**IFB No. 17-26 Eisenhower Middle School HVAC and Roof Access Renovations**

**RE: ADDENDUM NO. 1**

Changes to Bidding Documents Dated January 13, 2017

PROJECT: EISENHOWER MIDDLE SCHOOL  
HVAC AND ROOF ACCESS RENOVATIONS  
ROCKFORD PUBLIC SCHOOLS 205  
ROCKFORD, ILLINOIS

5 LADDER SECTION  
(IN OPEN POSITION)  
SCALE: 3/4" = 1'-0"

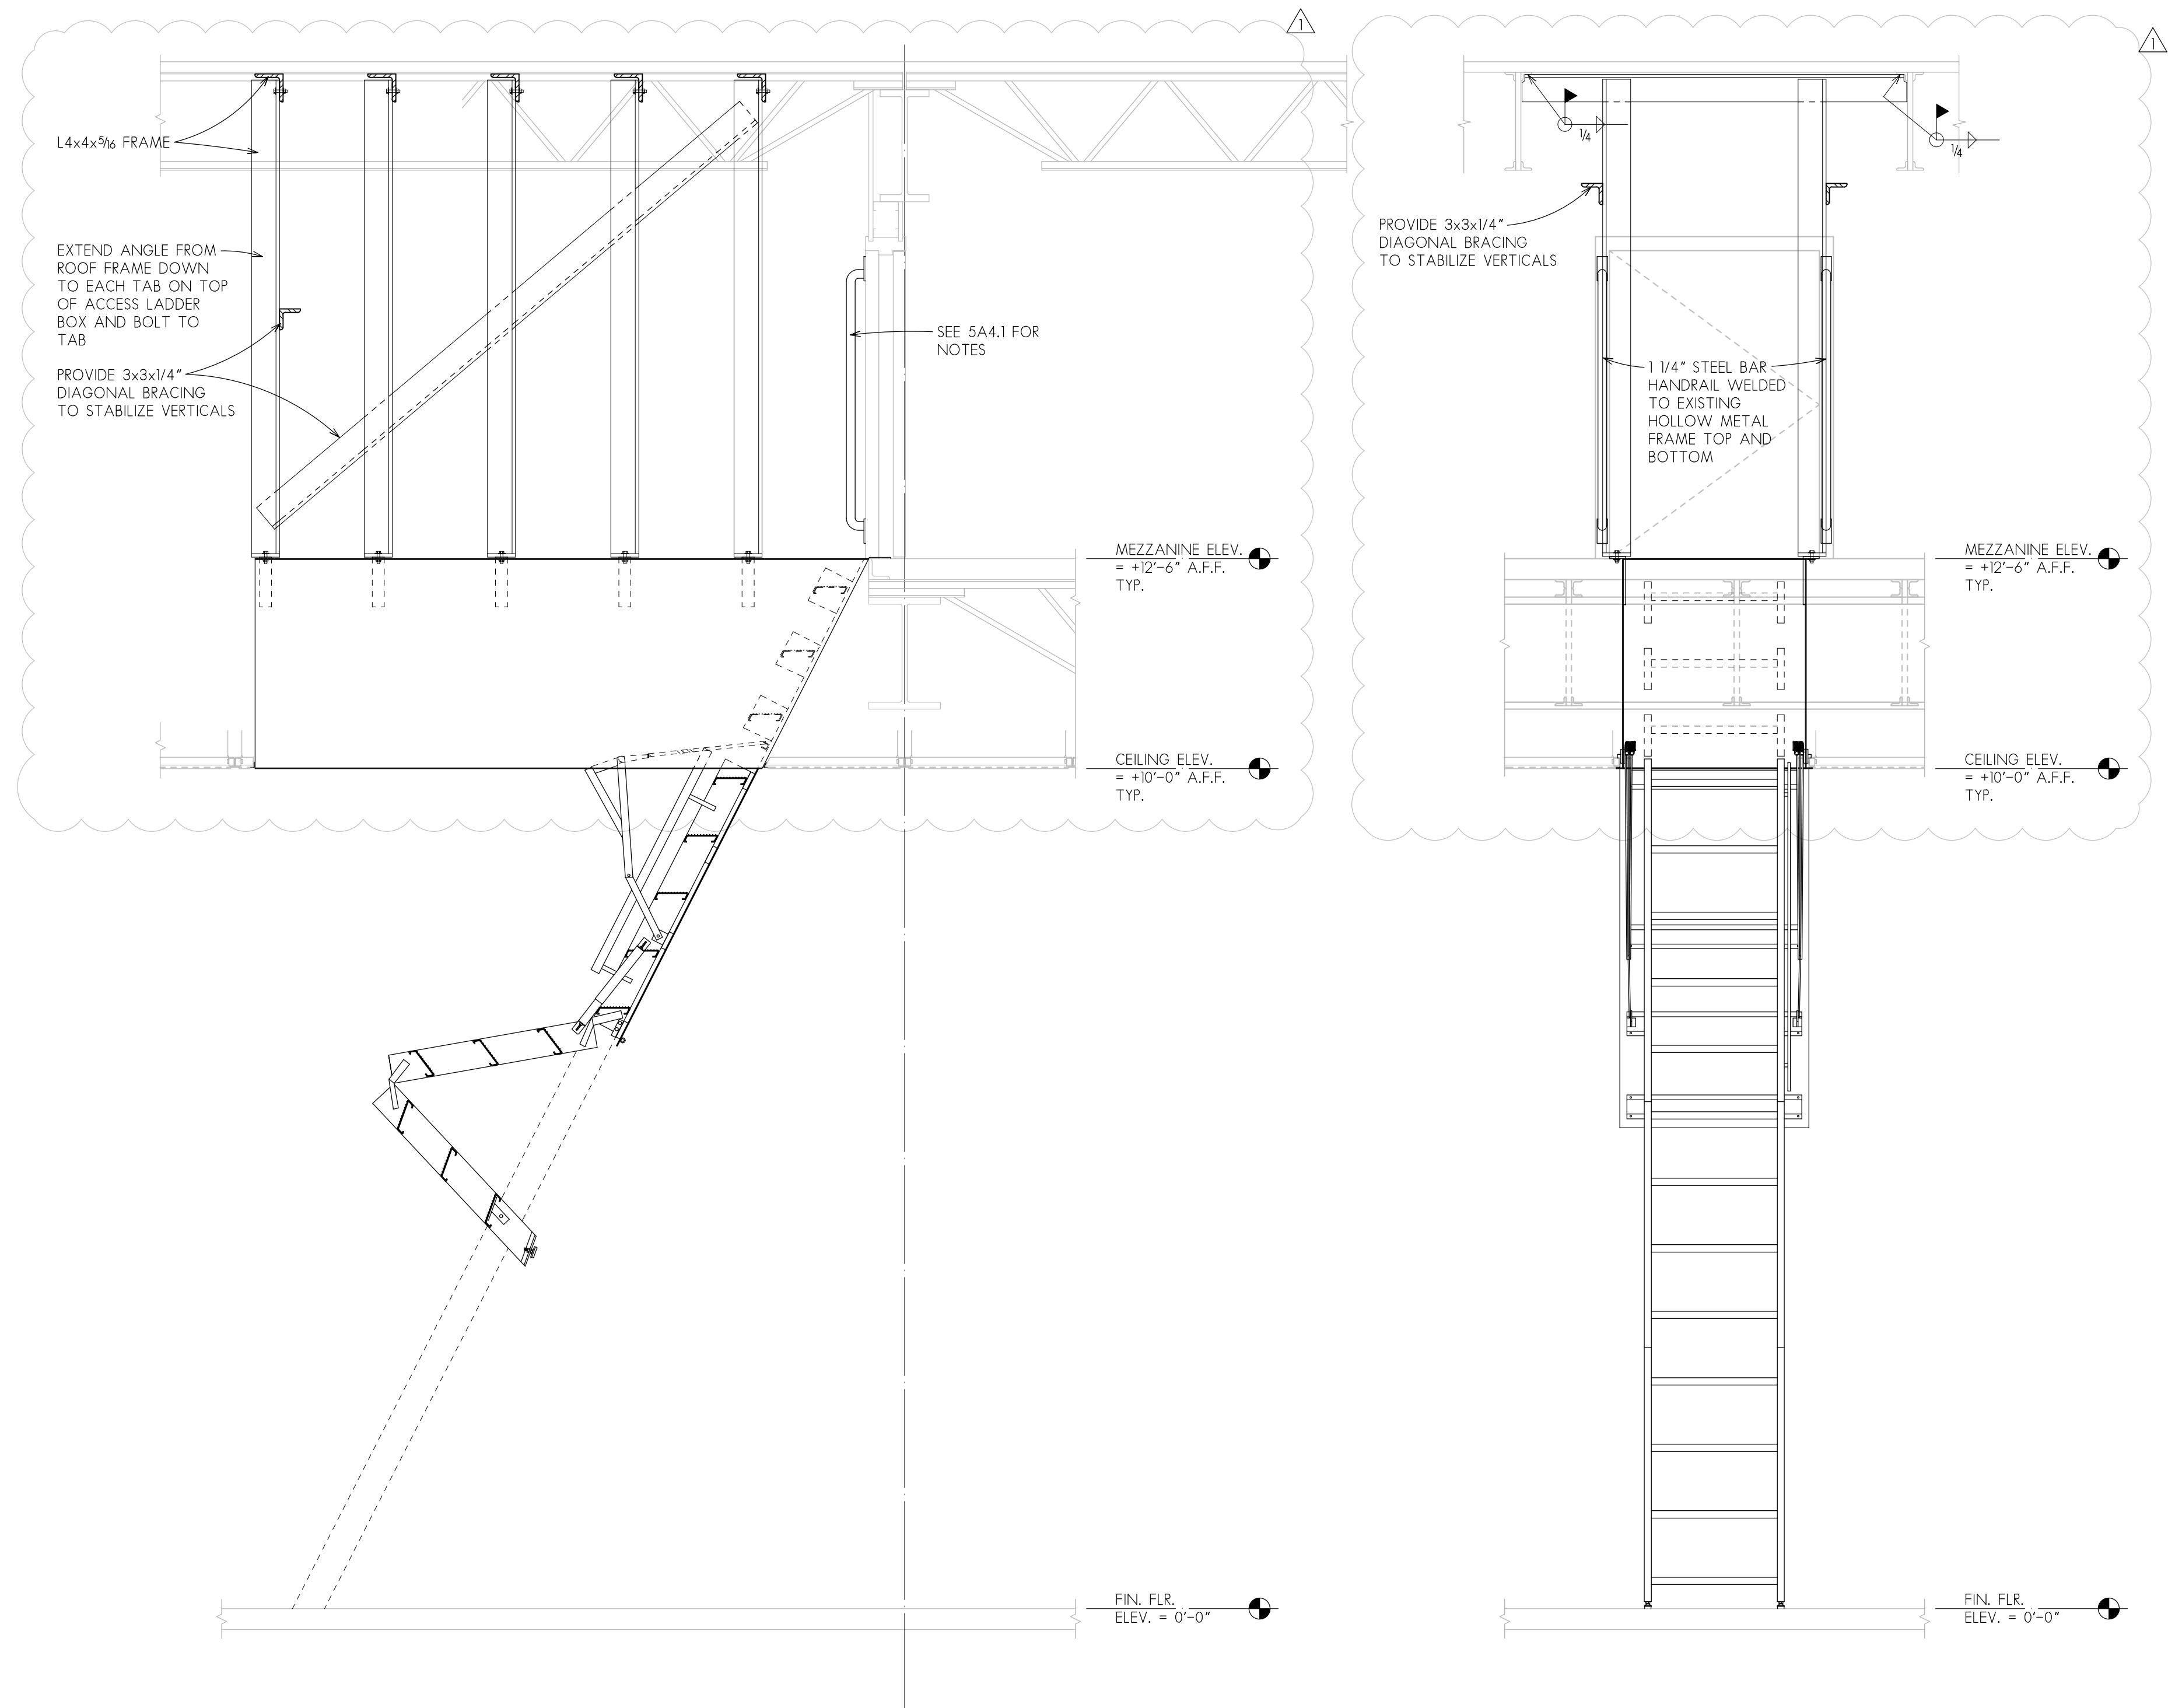
10. The 13'-6" floor to ceiling height requires a "deep box" vs. the "deep angle" stair that is detailed. The deep box (vertical section of stairway "inside the box") is what you show for the other six(6). The 13'-6" floor to ceiling height requires that the stairway be made 22" wide in lieu of the standard 30". This should be clarified or the other option may be to extend the framing down to "lower" the ceiling height. The "end" of the stairway is perpendicular to the doorway and ends into only what is probably open

11. The 10'-0" floor to ceiling height could allow a "deep angle" stair installed vs. the "deep box" shown. This would allow the stair to continue on an angle in lieu of having a vertical section at the top. Please clarify.

12. The stair box is shown to abut the mezzanine only at the top width (30") of the stair. There is no support for the stair box at the other three (3) sides. Will this arrangement support the stair? Is the deep box vertical section of the stair aligned with the beam placed this way to allow the box to be supported only along that edge?

***Refer to drawings A4.1 and A4.2.***

***Refer to drawings A4.1 and A4.2.***

***Refer to drawings A4.1 and A4.2***
